**BEFORE THE HEARINGS PANEL
FOR THE QUEENSTOWN LAKES PROPOSED DISTRICT PLAN**

IN THE MATTER of Hearing Stream 09
- Resort Zones

**STATEMENT OF EVIDENCE OF MARION READ
ON BEHALF OF QUEENSTOWN LAKES DISTRICT COUNCIL**

LANDSCAPE – JACKS POINT ZONE

Plan showing differences between ODP and PDP Structure Plans

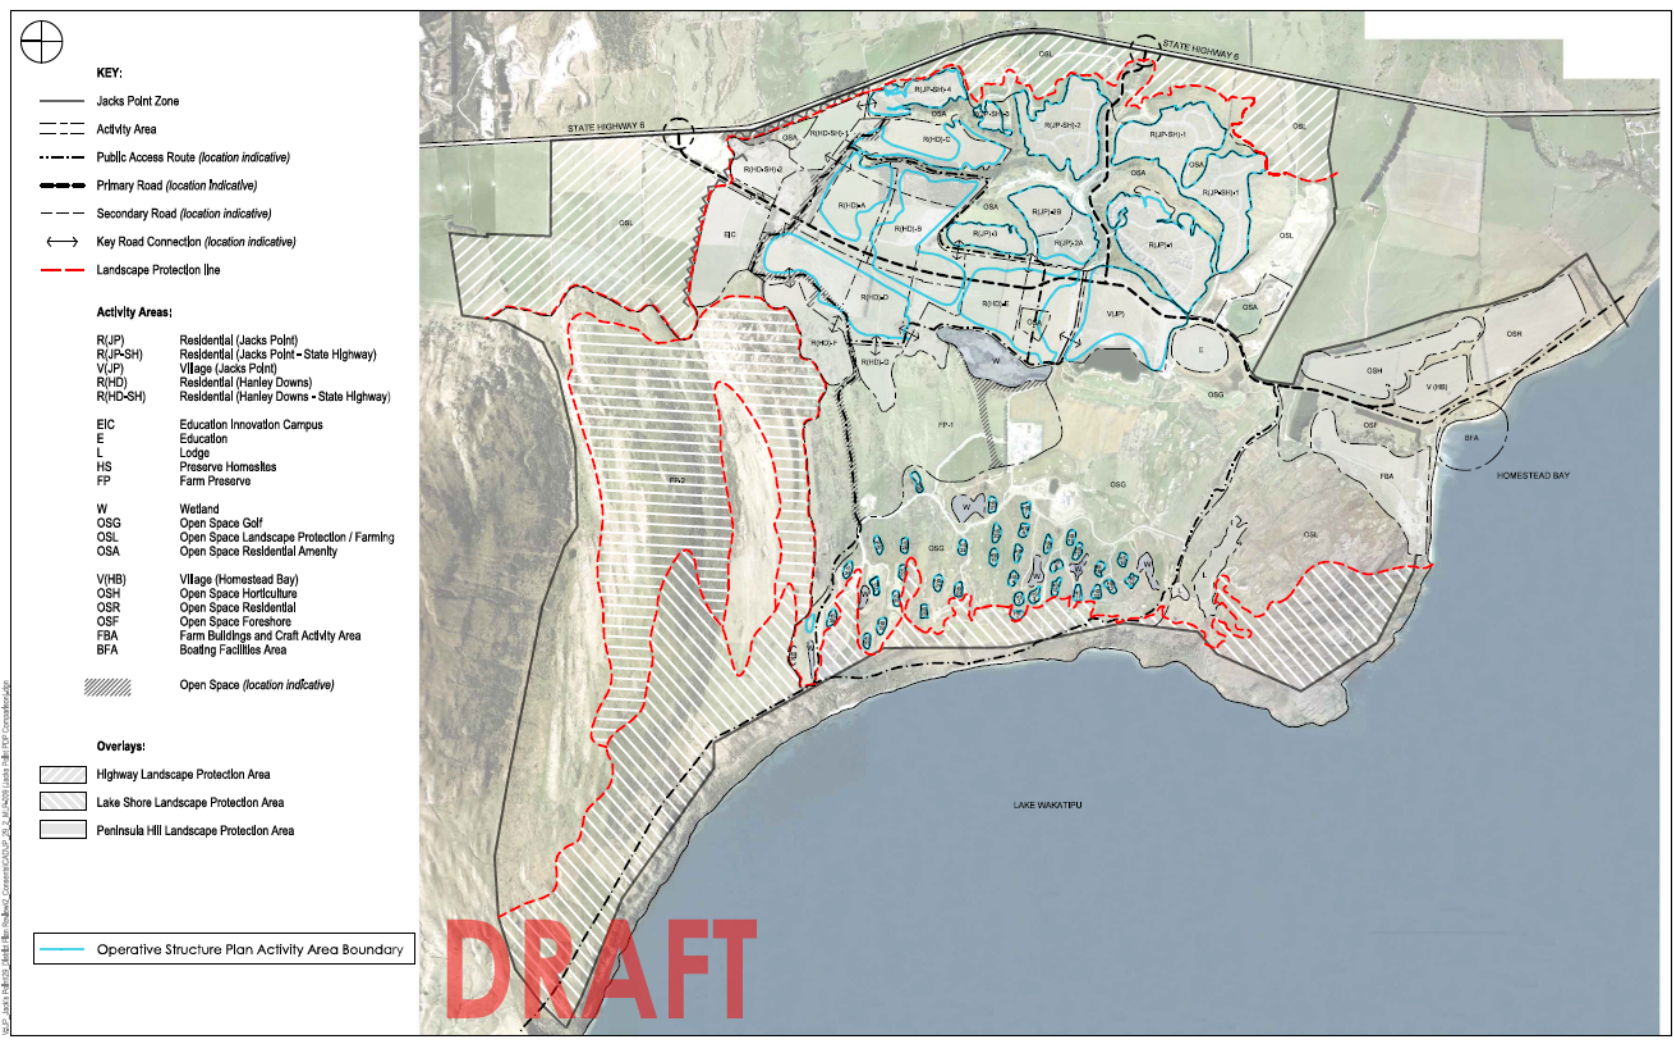
4.11 The following discussion is complemented by the plan attached as **Appendix 1**, which overlays the PDP and ODP Structure Plans and helps to explain the areas outlined below. It should be noted that the spatial Structure Plan within the ODP contains areas not defined by the Site Standards, but modified by other rules. The PDP has tried to address this inconsistency, but still distinguishes between Residential (Jacks Point) and Residential (Hanley Downs) even though the rule framework provided does not.

- 6.4** R(JP-SH)-4 has been increased in area (from the ODP version) from 5.7ha to 6.36ha. It is my understanding that this is so as to include an existing extension of the residential development area which was consented by RM130669. The effects of this extension were assessed at the time and additional planting and mounding undertaken to mitigate the potential effects of this development on views from the State Highway. As such it seems appropriate that the PDP Structure Plan be updated to reflect this.

- 7.1** R(JP)-1 has been expanded by 0.76ha to its east over what was a part of the Open Space activity area in the ODP Structure Plan. It is my understanding that this is so as to include seven additional lots that were created by resource consent RM090252. The effects of this extension to the residential area were assessed at the time. Extending the activity area to incorporate these lots therefore seems appropriate.

- 7.2** R(JP)-2 has been expanded by 0.84ha. This appears to entail moving the western boundary of the activity area further west so that it coincides with Woolshed Bay Road. Currently the owners of the lots to the east have an open buffer between them and this road, and more significantly, between them and the anticipated development to its west within the Hanley Downs portion of the zone. While development in this part of the zone will diminish the naturalness of their outlook significantly, the development of this land adjacent to the road, which would be facilitated by this change in activity area, would bring development much closer to them.

- 7.5** I consider that Activity Area R(HD)-F extends too far to the west and that residential development within this area should be limited to areas outside of the ONL as identified on PDP Planning Map 13. This is illustrated within the revised Structure Plan included in **Appendix 1** to Ms Jones's s42A Report (ie, her recommended chapter).
